BOARD OF ADJUSTMENT AGENDA

Board of Adjustment Regular Meeting - Thursday, February 27, 2025 - 2:00 p.m.
City Hall - City Commission Chambers, 100 North U.S. #1, Fort Pierce, Florida

Five (5) Variances - Dutch Bros Coffee - 2050 S US Highway 1

PZVAR2024 – 00002
DUTCH BROS – VARIANCE REQUEST
2050 S US HIGHWAY 1

Variance 1

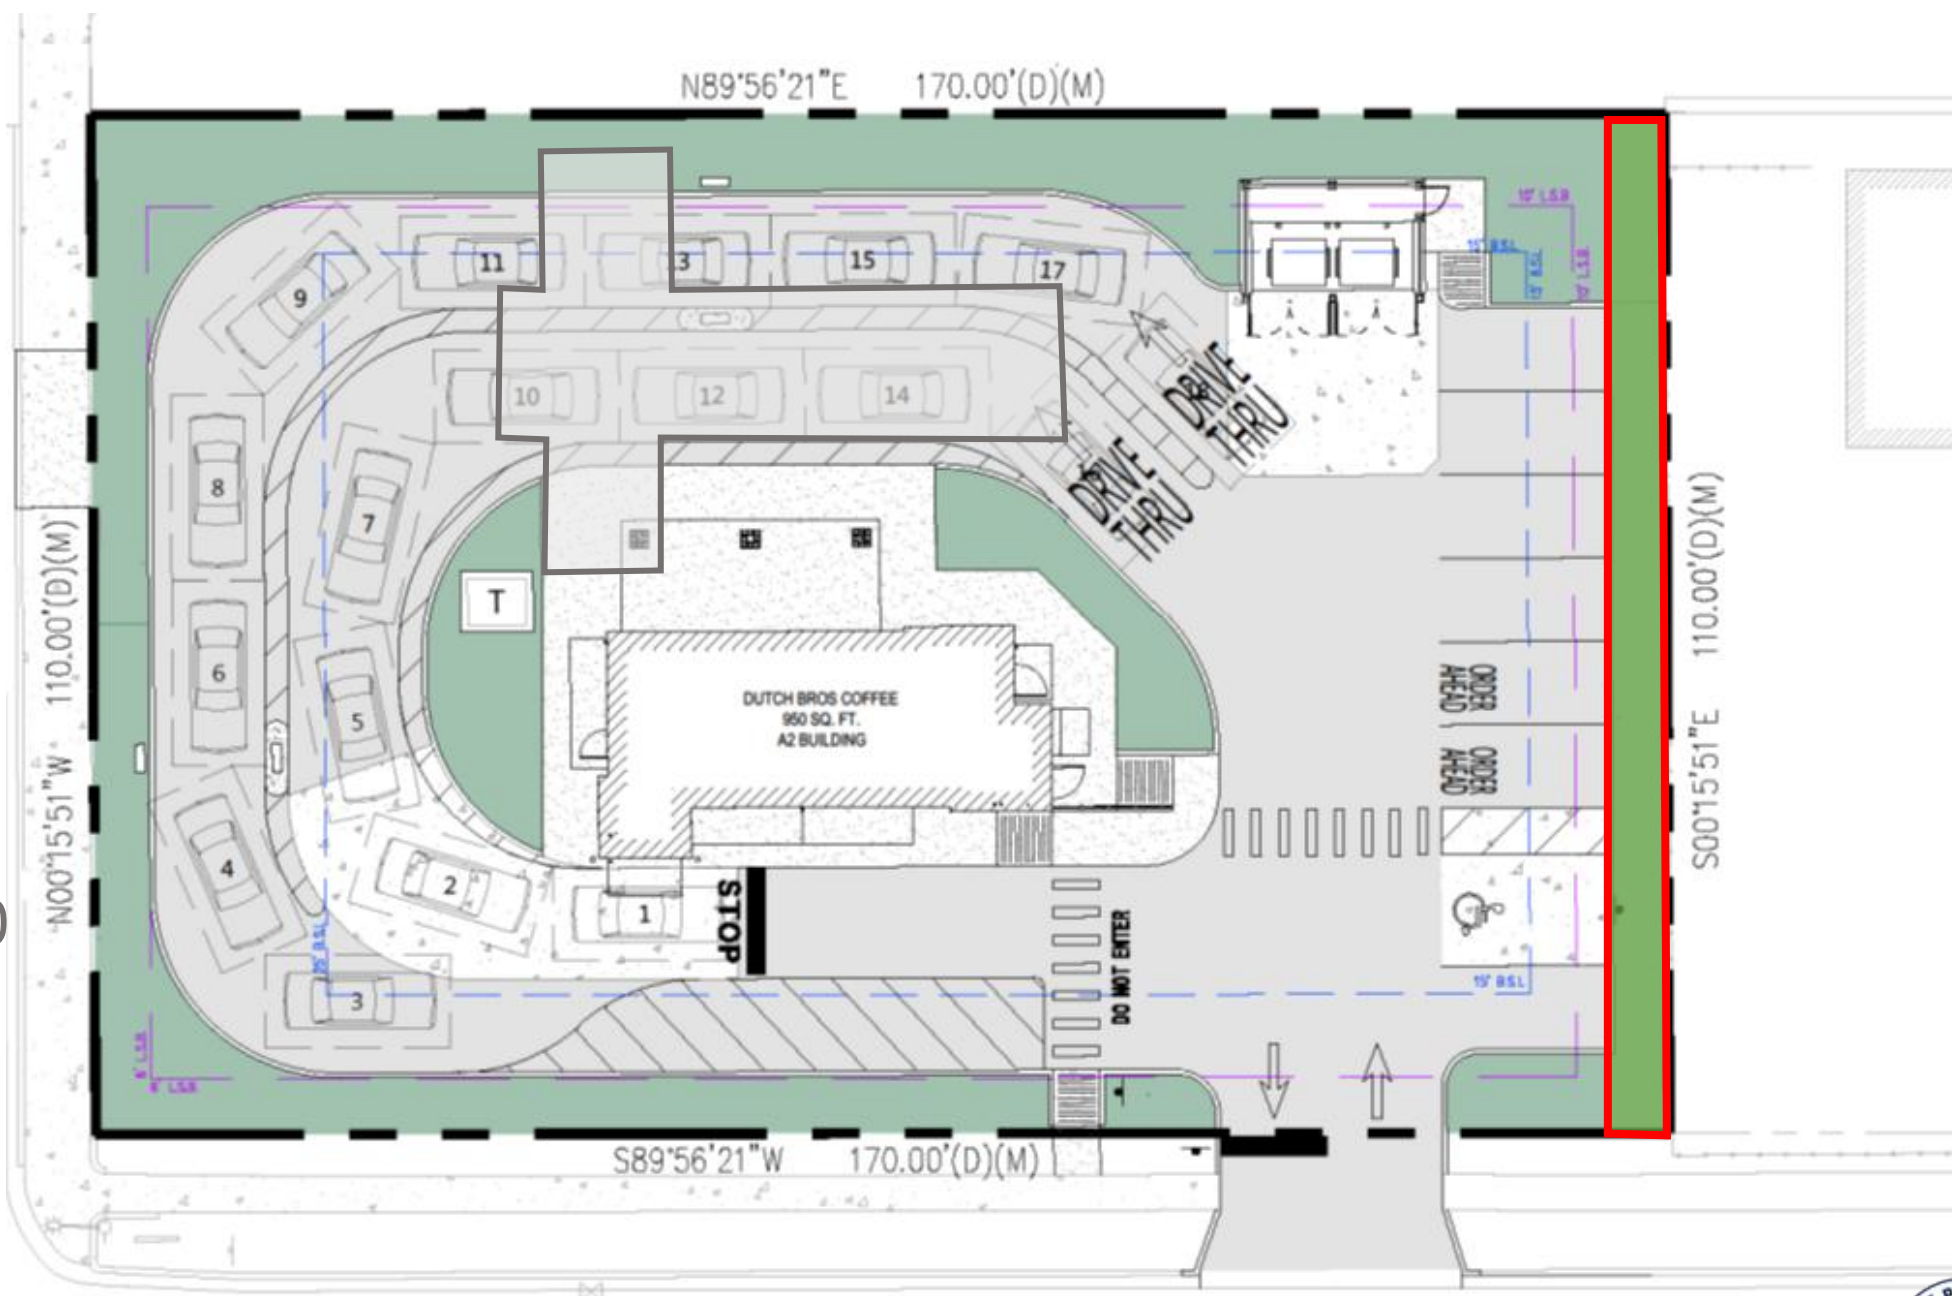
Variance from Section 123-37(6)a General Landscaping Requirements to allow the eastern landscape buffer to be reduced from 10 ft to 6 ft.

Staff Comment: The existing buffer in this location is 6ft

Variance 2

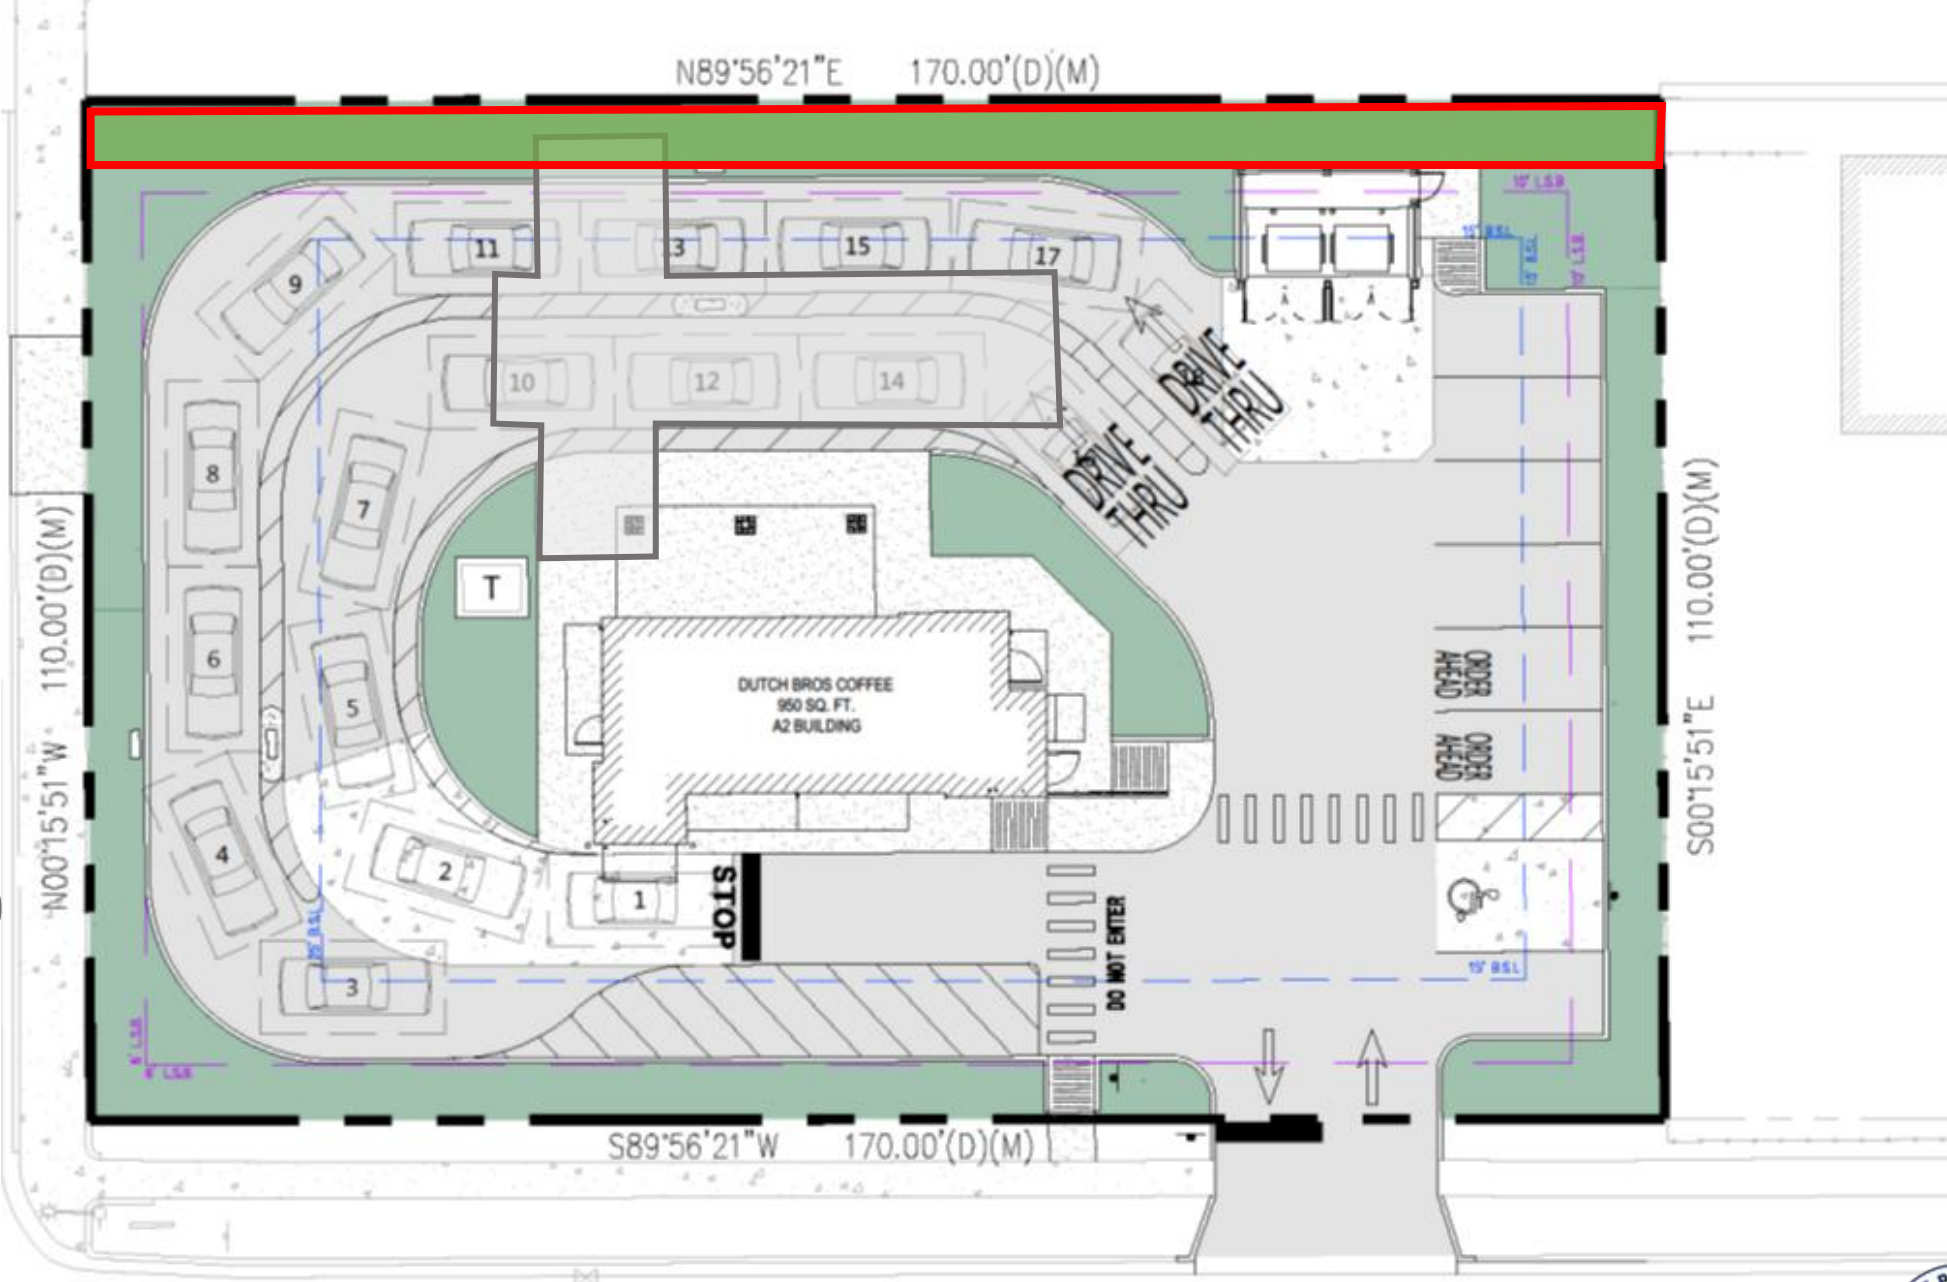
Variance from Sec. 123-37(6)a General Landscaping Requirements to allow the northern landscape buffer to be reduced from 10 ft to 6 ft.

Staff Comment: Approximately 60% of existing buffer in this location is 6ft

Variance 3

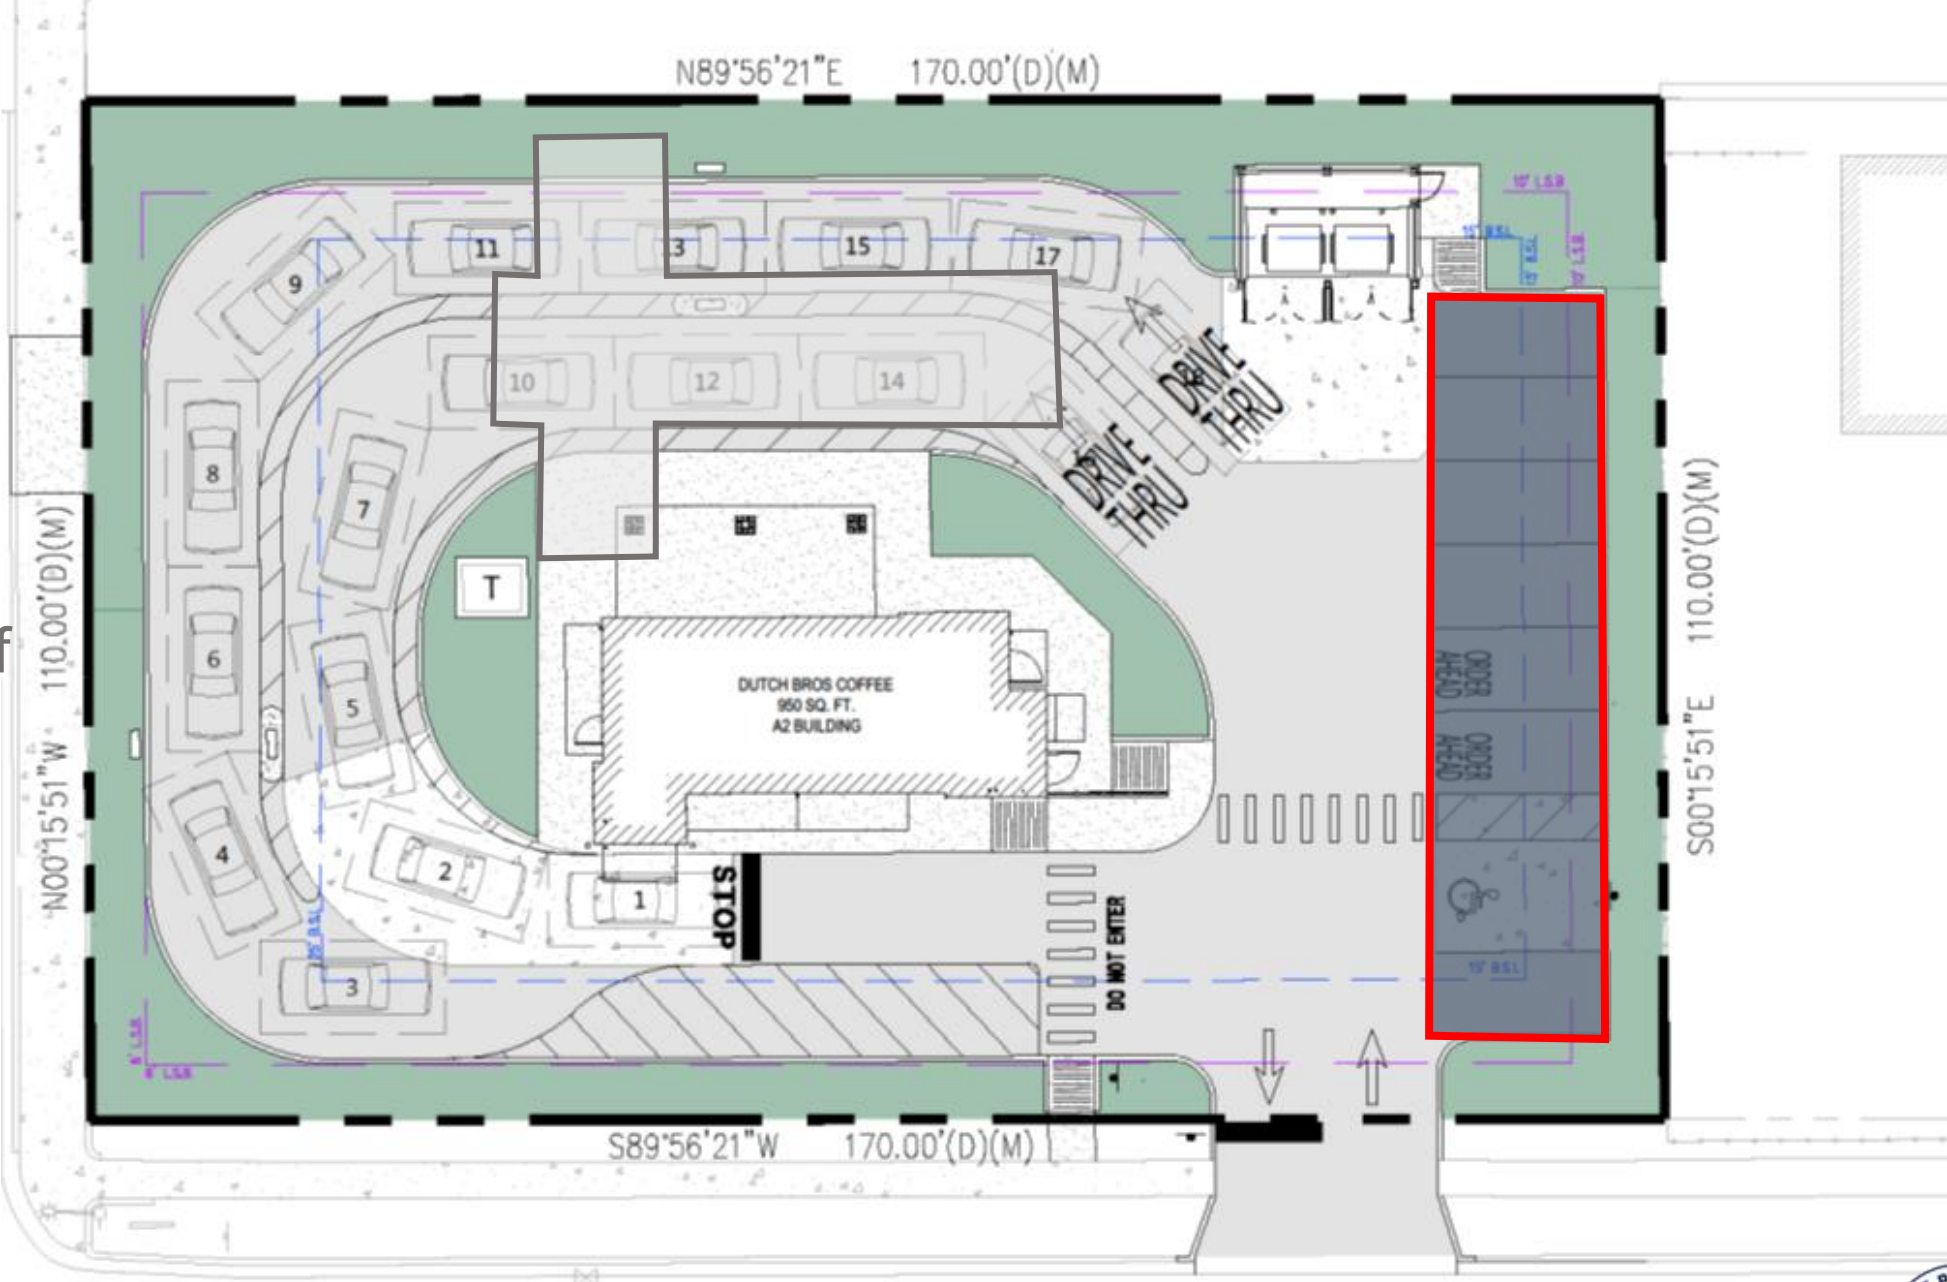
Variance from Sec. 125-315(c)(1) Off-Street Parking Design Standards to allow the minimum width of the parking spaces to be reduced from 9.5 ft to 9 ft and for the minimum depth to be reduced from 19 ft to 18 ft.

Staff Comment: Existing parking stalls are 9ft x 17ft.

Variance 4

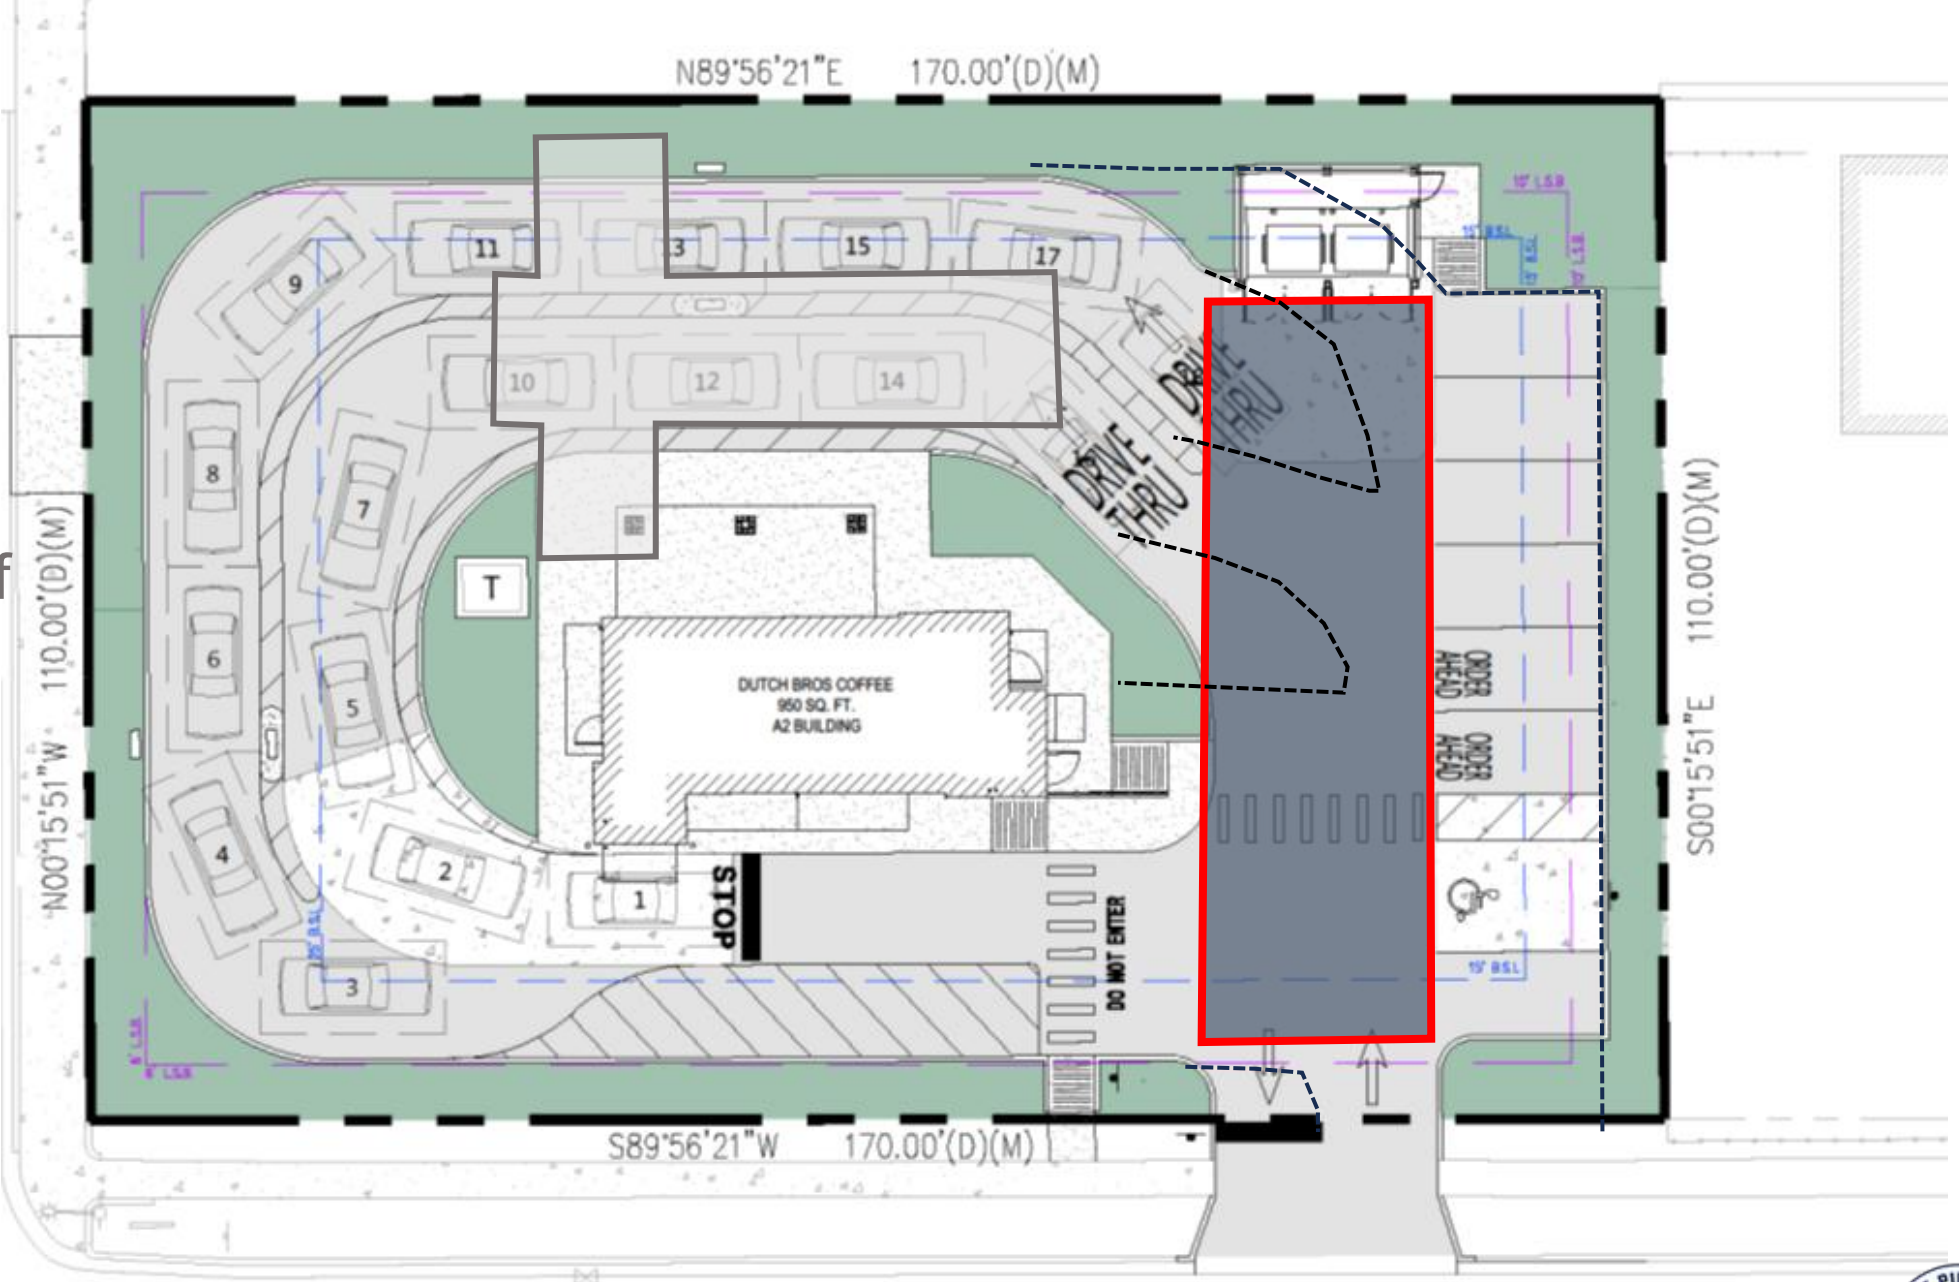
Variance from Sec. 125-315(c)(5) Off-Street Parking Dimensions to allow the minimum width of the drive aisle to be reduced from 26 ft to 24 ft.

Staff Comment: Existing drive aisle is 25ft.

CONCEPTUAL SITE PLAN

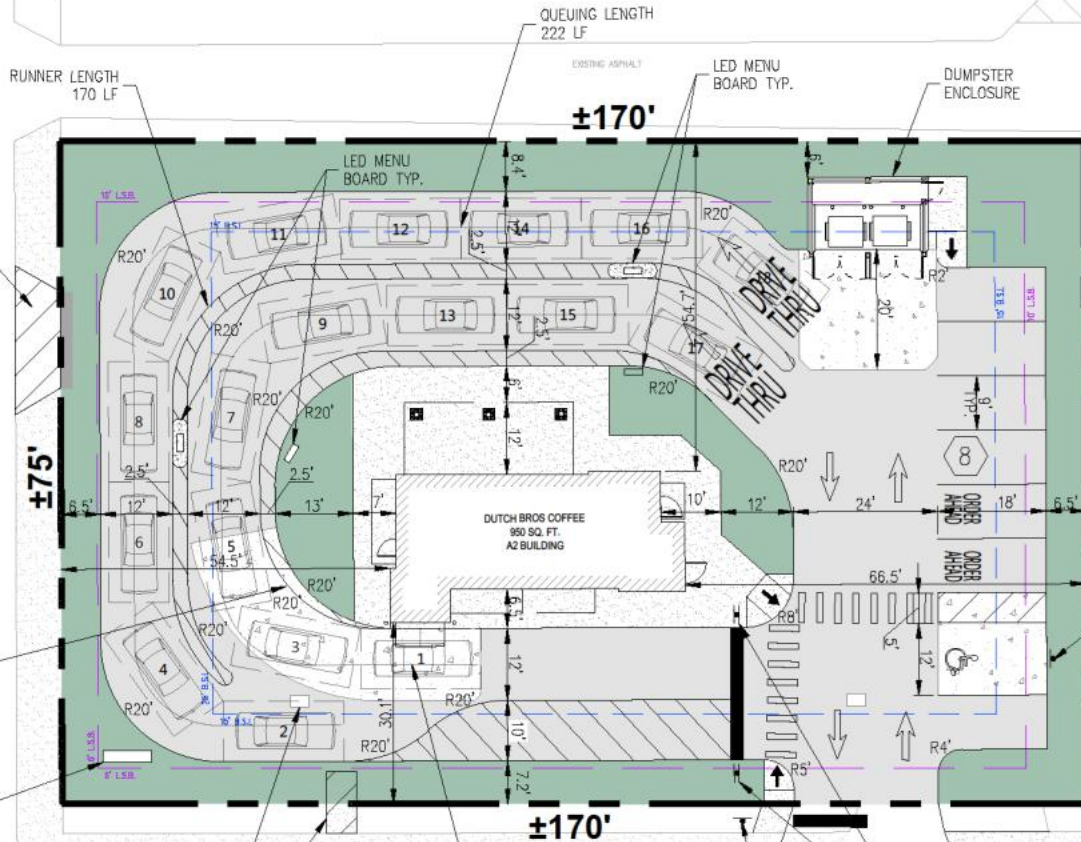
1. Tennessee Avenue is a City owned and maintained roadway, please show Right-of-Way information on Site Plan.
2. Show ADA ramps where needed/provided.
3. Ensure dumpster meetings current City standard (attached).

5. Provide dimensions/measurements for new entrance on Tennessee Avenue. Ensure entrance meets existing City standards (attached).
6. "Existing entrance to be closed" will need to be restored with curb & gutter, sidewalk, grass, etc. Coordination with FDOT will be required for work in their Right-of-Way.

7. All new sidewalk to be installed shall be a minimum 5' wide.
8. City Code requires parking stalls to have a standard width of 9.5' and length of 18' when abutting a landscaped area; please revise accordingly. In addition, a 26' wide drive aisle shall be provided for 90° parking.

9. How will cars be able to exit should they so desire? Recommend a bypass lane be added for vehicles that enter the establishment only to find the on-site parking is full and not wish to proceed through the drive-thru.
